Technical Service Information

FORD 4R100 PRELIMINARY INFORMATION

CHANGE: Beginning at the start of production for 1999 models, Ford Motor Company introduced a new transmission in some F250, F350, F450 and F550 Super Duty Trucks, equipped with the 5.4L, 6.8L and 7.3L engines. Basically the new 4R100 is a revised version of the previous E4OD transmission with a Power-Take-Off (PTO) window on the side of the case (See Figure 1). The revisions that have occurred however, have created many major engineering changes that have affected many internal and external parts that will affect service.

Figure 2

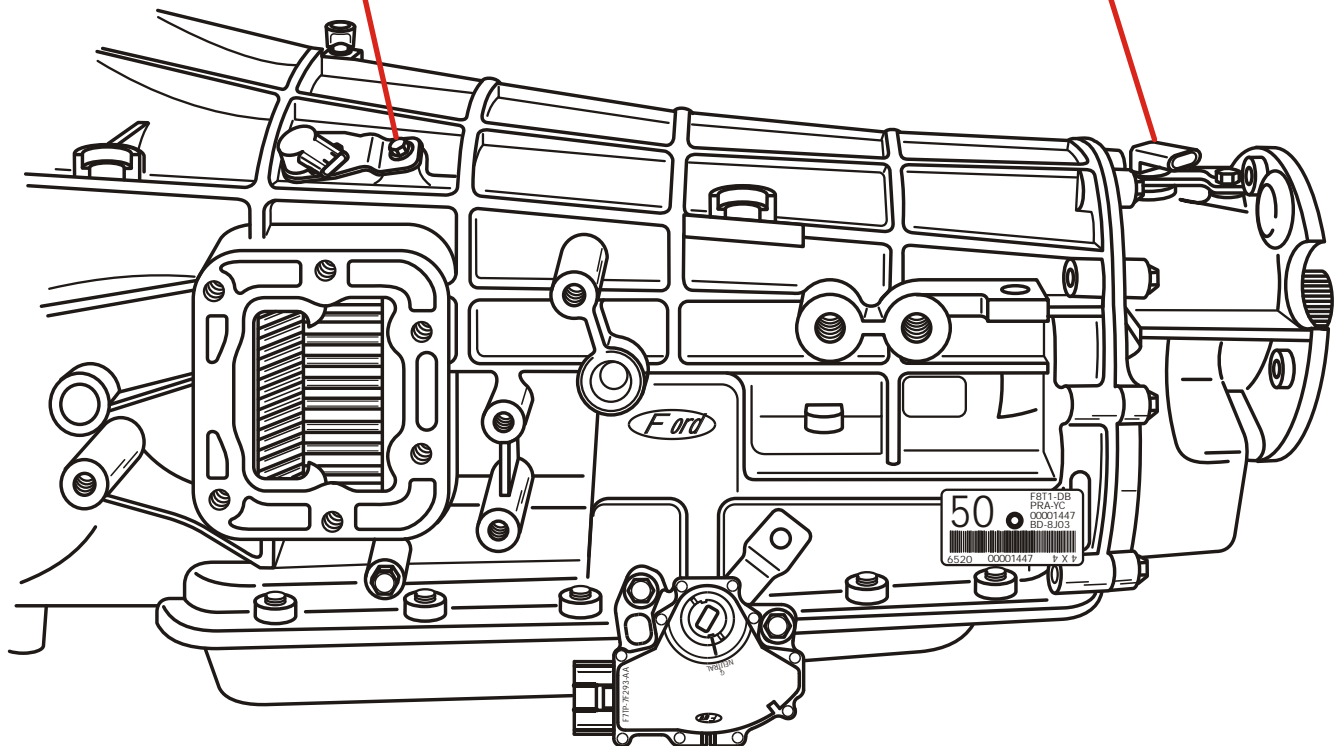
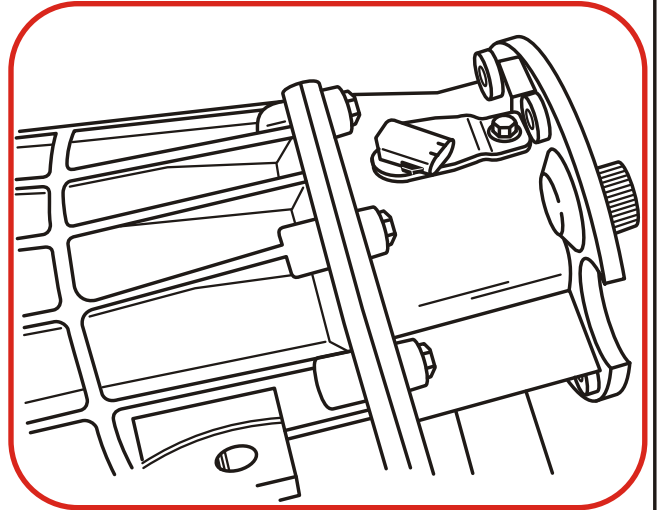
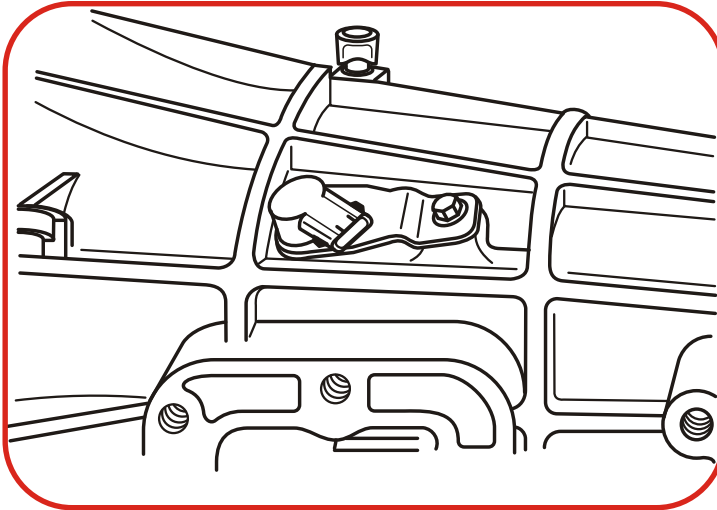
- (1) **TRANSMISSION CASE** - Now has a PTO window added to the left side of the case directly behind the front pump area, and a Turbine Speed Sensor has been added at the top of the case and triggered by a revised coast clutch drum (See Figure 2). Another change to the rear of the case is the addition of a Lube Orifice Plug to the Rear of the case, as shown in Figure 4, which also changes the extension housings.

- (2) **TURBINE SPEED SENSOR** - Added to the top front of the case on some models, as shown in Figure 2. We have also provided you with the resistance readings and OEM part numbers on both Turbine Speed Sensors, as the PTO and Non-PTO models use different sensors. Refer to Figure 2 for turbine speed sensor information.

- (3) **OUTPUT SHAFT SENSOR** - Output Shaft Speed sensor was added to the top of the extension housing on some models, as shown in Figure 2. OSS is triggered by an added rotor pressed onto the output shaft, which requires a new tool to position the speed rotor properly *if* it is removed during overhaul, as shown in Figure 3. The park gear is also now pressed onto the output shaft, and the number 13 thrust washer has been changed to a thrust bearing as shown in Figure 3. We have provided you with the resistance reading and the OEM part number for the output shaft speed sensor. Refer to Figure 2 for output shaft speed sensor information.

*PTO Models Only = 496-1244 Ohms Resistance
Part Number F81Z-7M101-BA*

*Non PTO Models Only = 781-1979 Ohms Resistance
Part Number F81Z-7M101-AA*

*All Models = 781-1979 Ohms Resistance
Part Number F81Z-7M101-AA*

Figure 3

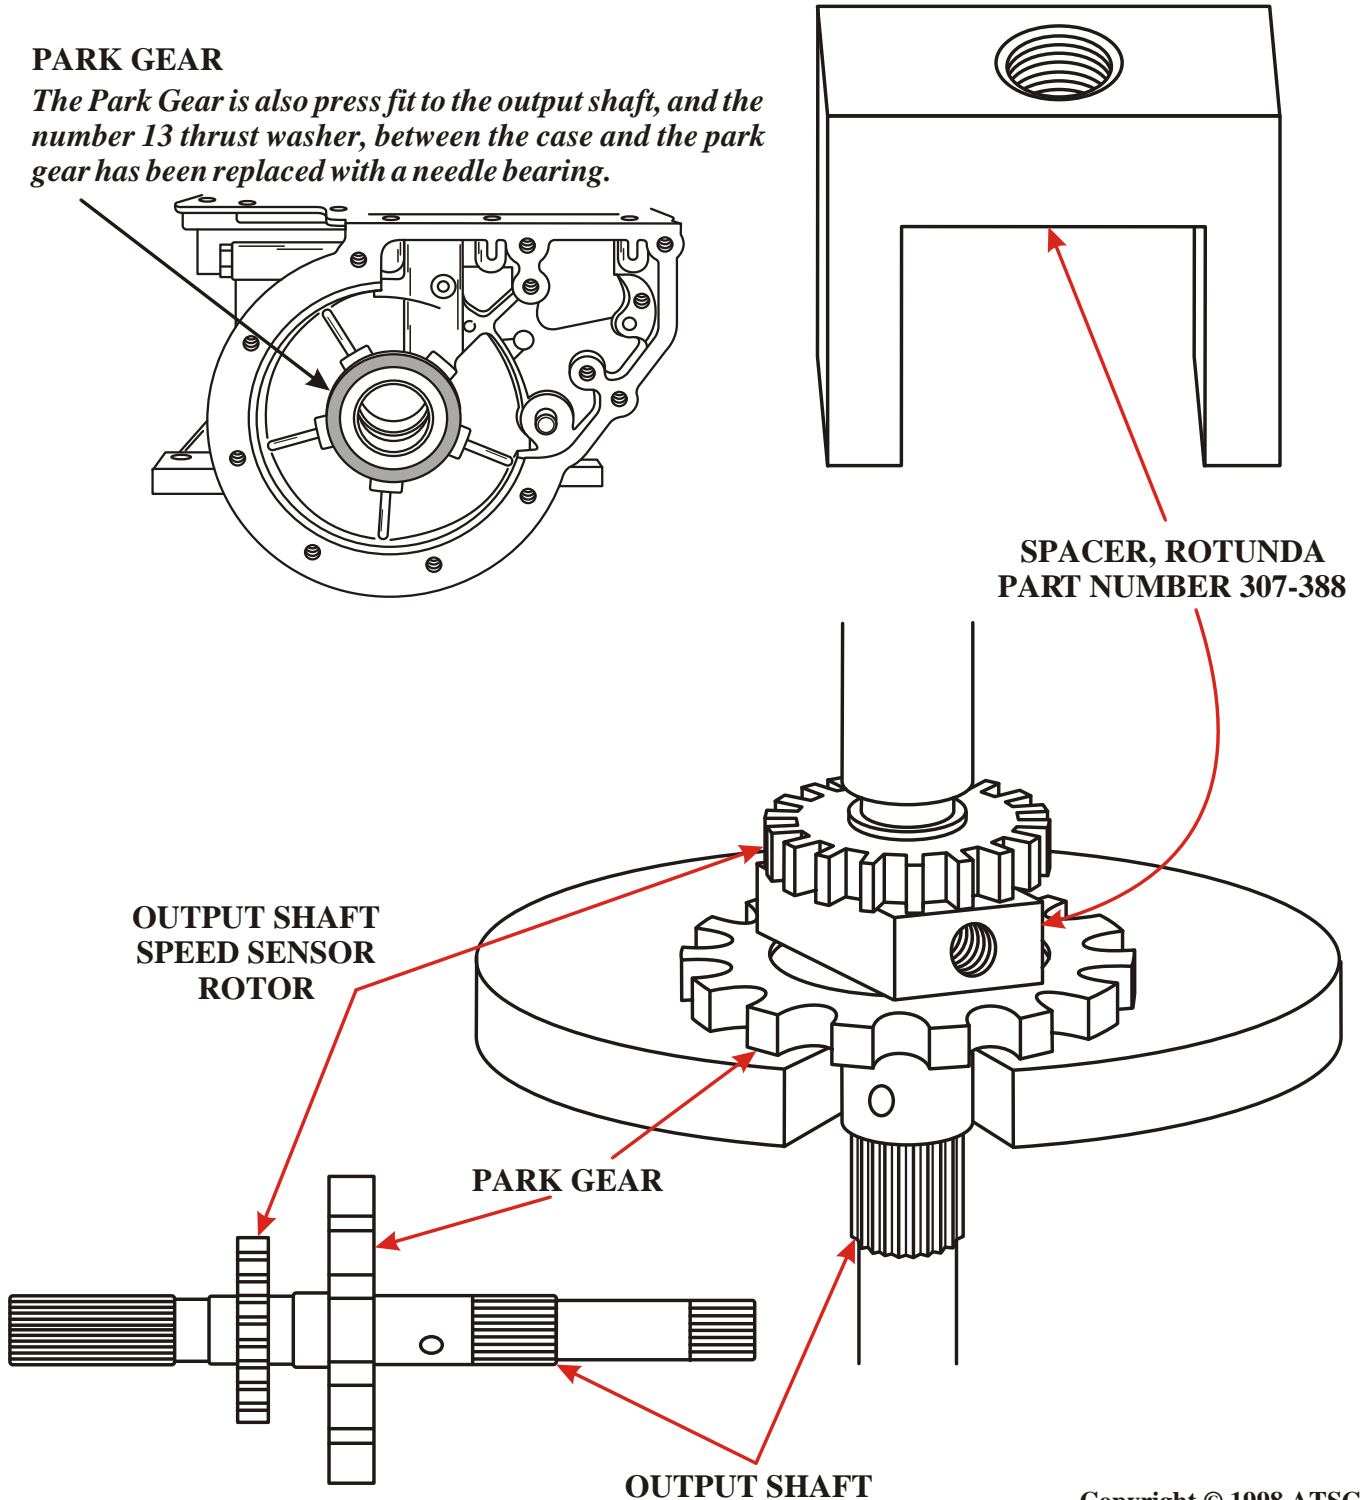
Output Shaft Speed Sensor Rotor is press fit to the output shaft and requires new Spacer Tool, Rotunda No. 307-388 for spacing the speed sensor rotor the proper distance from the park gear, if it was removed from the output shaft during service.

The Park Gear is also press fit to the output shaft, and the number 13 thrust washer, between the case and the park gear has been replaced with a needle bearing.

Figure 4

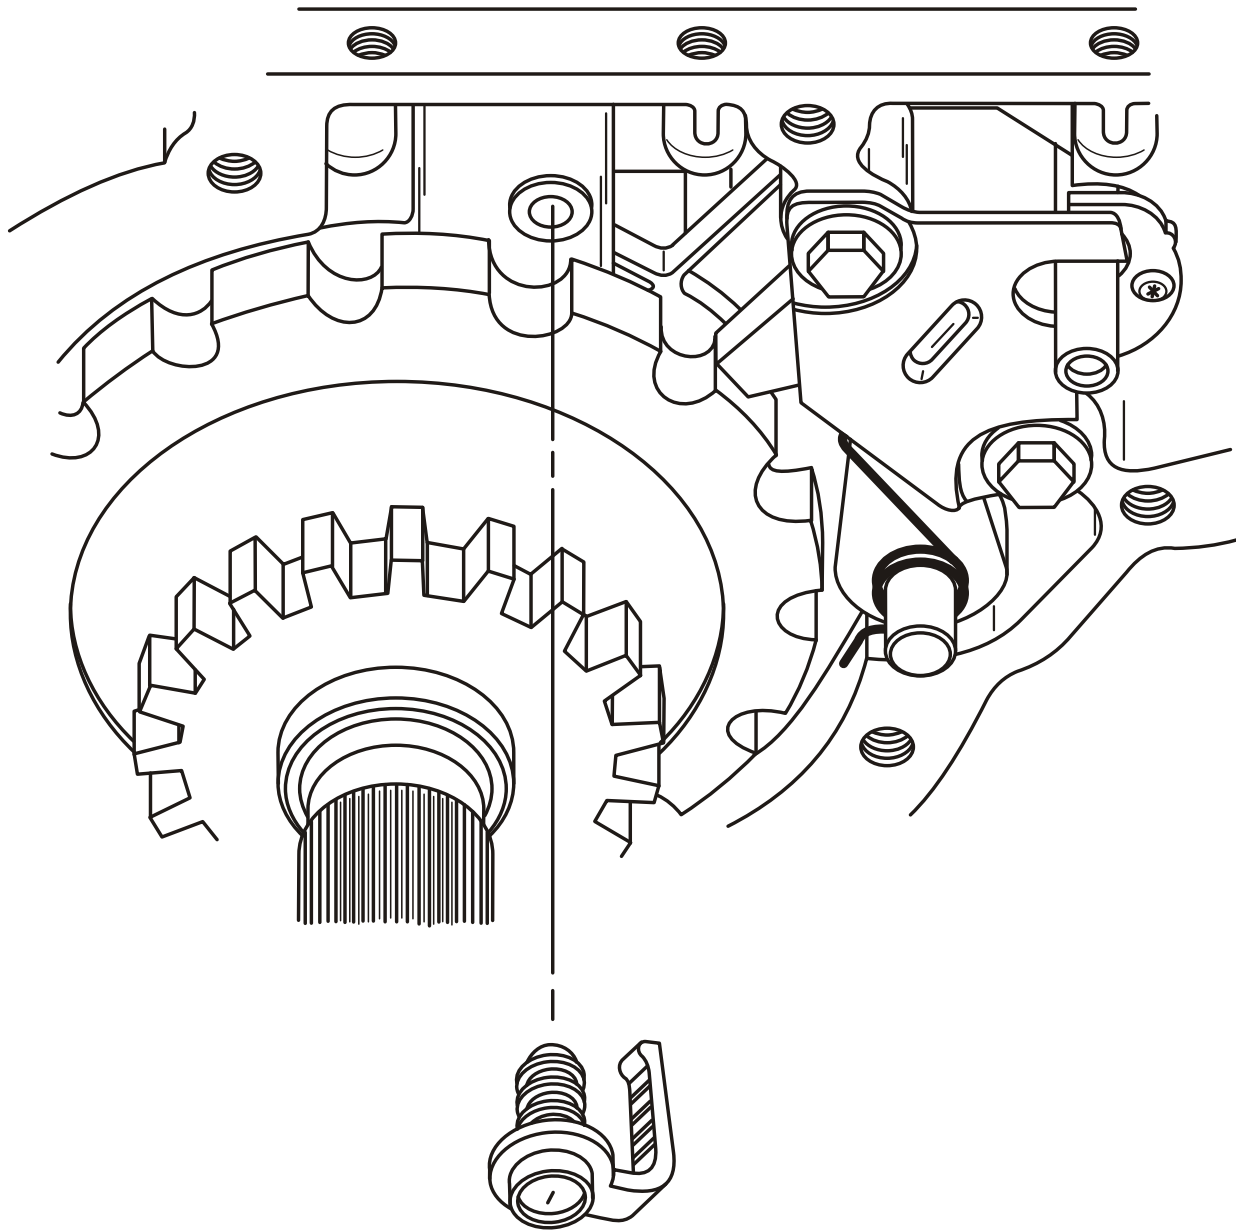
- (4) **LUBE ORIFICE PLUG** - Added to the rear of the case in the lube circuit to provide added lubrication to the extension housing bushing on 2WD models. To retain common cases the 4WD models will also have the lube orifice plug installed, as well as E4OD cases produced after July 24, 1997. Lube Orifice Plug is available under OEM part number F81Z-7E380-AA, and should be replaced on rebuild. Refer to Figure 4.

**LUBE ORIFICE PLUG
FORD PART NUMBER
F81Z-7E380-AA**

Figure 5

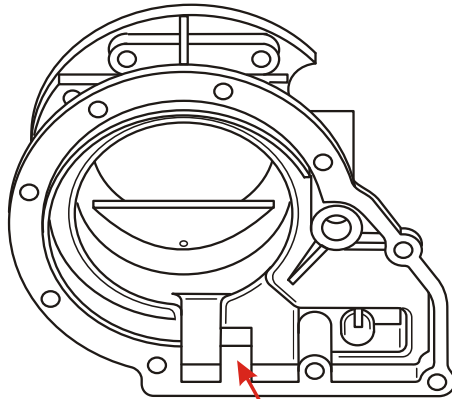
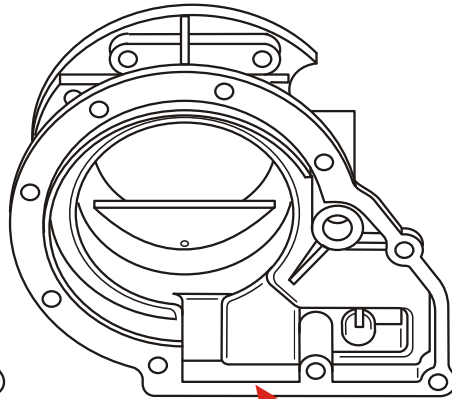
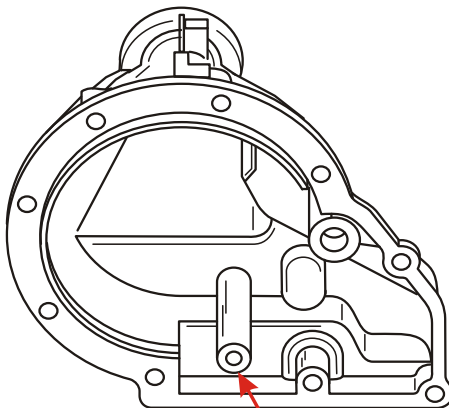
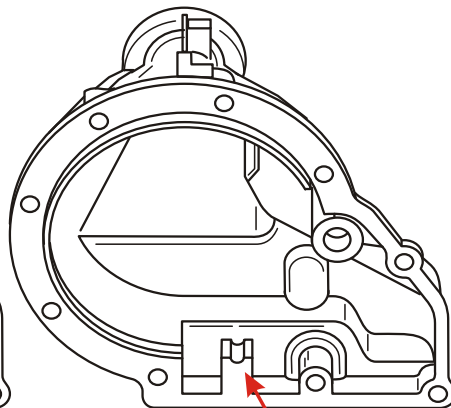
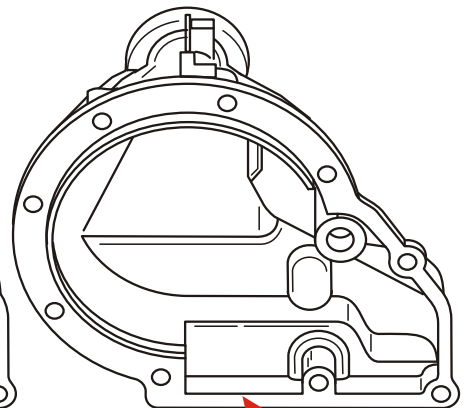
- (5) **EXTENSION HOUSING** - Has an added boss or shoulder to retain the lube orifice plug in position in the transmission case, as shown in Figure 5. Notice that the 6.8L and 7.3L, 2 wheel drive extension housing has added a new passage to the extension housing bushing, much like the 4L80-E. All 4R100 and E4OD transmissions equipped with the lube orifice plug *must* use an extension housing with the shoulder or boss. Failure to do so could blow the lube orifice plug out and exhaust all lube oil, which would be catastrophic. Refer to Figure 5.

NOTE: *Extension Housings are model sensitive. Refer to Ford Motor Co. parts list for proper part numbers.*

Figure 6

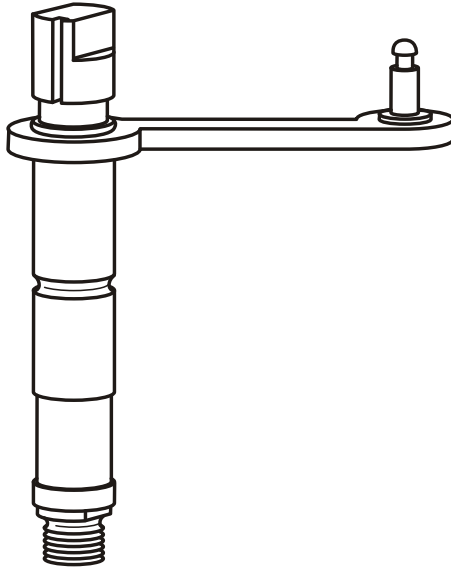
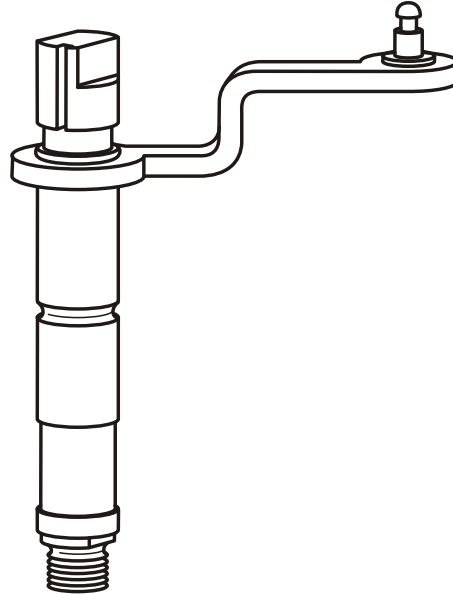
- (6) **MANUAL SHIFT LEVER** - There are two different external shift levers for this unit, one for Non-PTO transmissions and one for transmissions with the PTO option, as shown in Figure 6. We have provided you with the "Stamping" number as well as the OEM part number for both, as shown in Figure 6.

FORD PART NUMBER
F81Z-7A256-AA

FORD PART NUMBER
F7UZ-7A256-BB

Figure 7

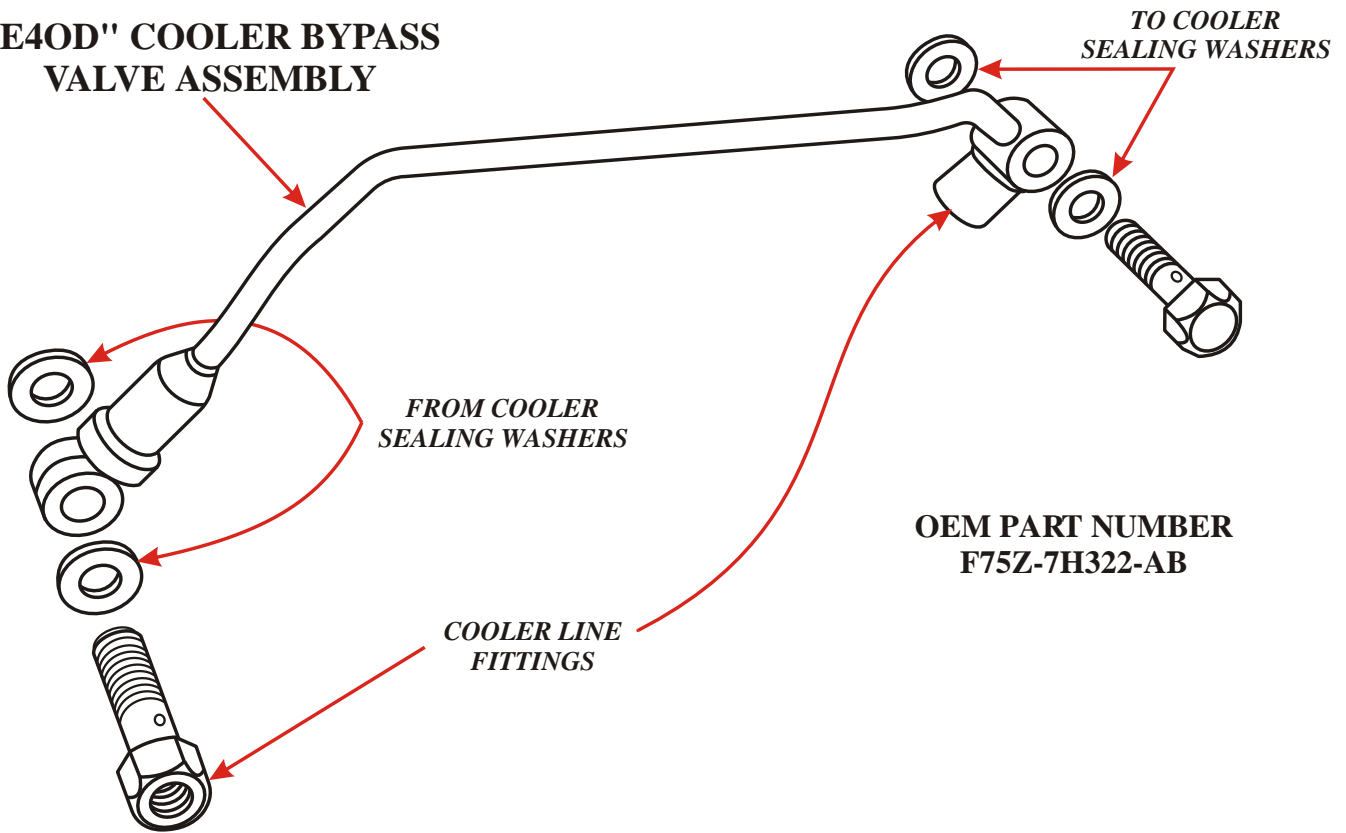
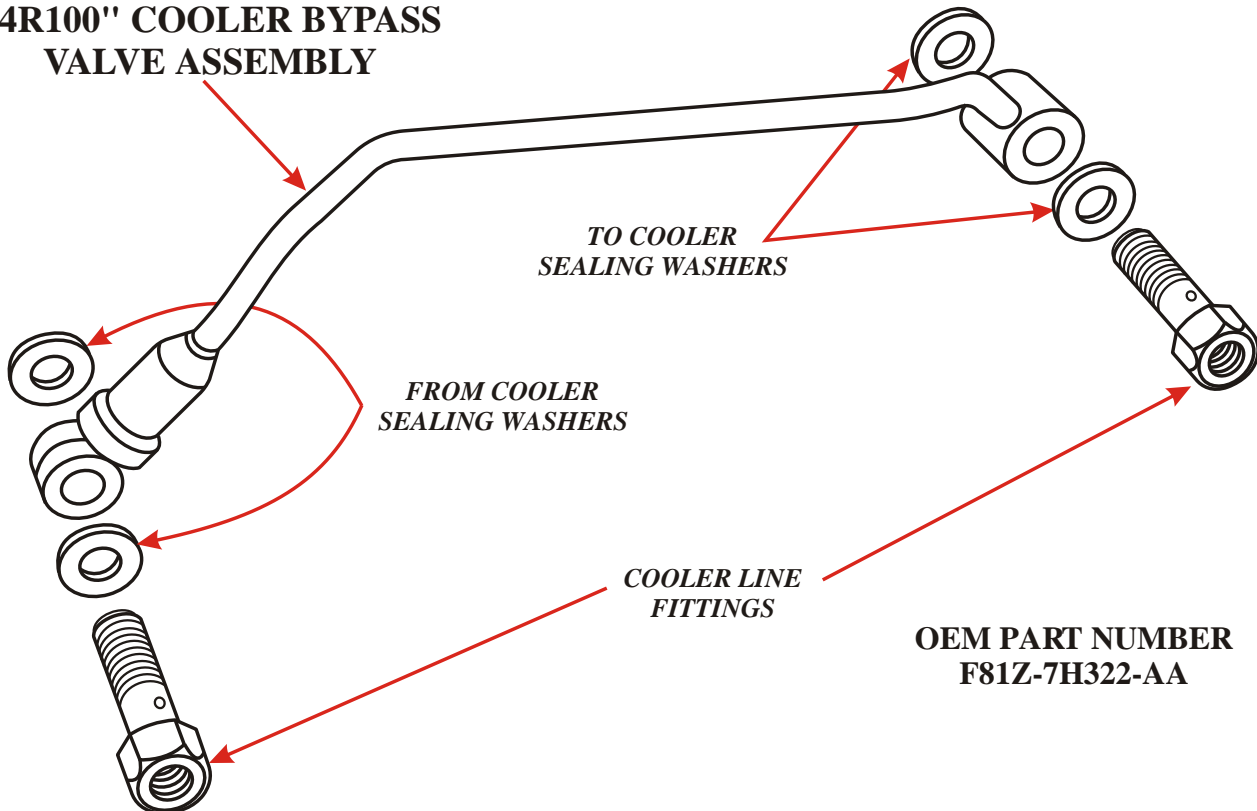
- (7) **COOLER BYPASS VALVE** - Similar to the Cooler Bypass Valve on the E4OD that provides lubrication to the transmission in case of blocked or partially blocked coolers. We have given you OEM part numbers for both and both bypass valves are illustrated in Figure 7.
